Access Compliance Report Public Rights-of-Way (Curb Ramps)

Intersection ID: 4031 Main Street: MALLARD_CREEK_RD Cross Street: DRIWOOD_CT Location: E

ADA ID: 911E99B67693 Ramp Type: BlendTrans1 Initial Pass/Fail: Fail Overall Compliance: No Severity Score: 17.5

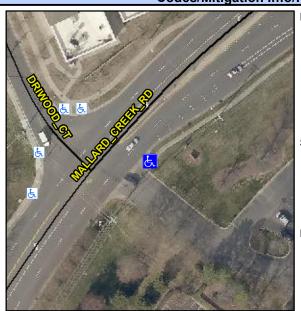
Not Found, R304.5.1

Field Measurements/Component Compliance					
Compliance Description		Data	Comp	liance Description	Data
N/A	Ramp Length (in)	58.5	Yes	BlendTrans Slope (%)	3.2
No	Ramp Width (in)	32.5	Yes	BlendTrans XSlope (%)	0.1
N/A	Flare Type LT	N/A	N/A	Flare Type RT	N/A
N/A	Flare Slope LT (%)	N/A	N/A	Flare Slope RT (%)	N/A
N/A	Flare Traversable LT?	N/A	N/A	Flare Traversable RT?	N/A
N/A	Landing Length (in)	N/A	N/A	DWS Provided?	N/A
N/A	Landing Width (in)	N/A	N/A	DWS Contrast?	N/A
N/A	Landing Slope (%)	N/A	N/A	DWS Length (in)	N/A
N/A	Landing X Slope (%)	N/A	N/A	DWS Full Width?	N/A
N/A	Landing Curb? (Y/N)	N/A	N/A	DWS Offset (in)	N/A
N/A	Shared Landing?	N/A			
N/A	Gutter Ponding?	N/A	N/A	Gutter Slope (%)	N/A
N/A	Gutter Lip Ht (in)	N/A	N/A	Gutter X Slope (%)	N/A
N/A	Painted X Walk1?	No	N/A	Painted X Walk2?	N/A
	X Walk 1 Direction	To NW		X Walk 2 Direction	N/A
	X Walk 1 Width (in)	N/A		X Walk 2 Width (in)	N/A
	X Walk 1 Slope (%)	6.9		X Walk 2 Slope (%)	N/A

Remove & Replace Curb Ramp With
Two New Directional Ramps or
Equivalent.
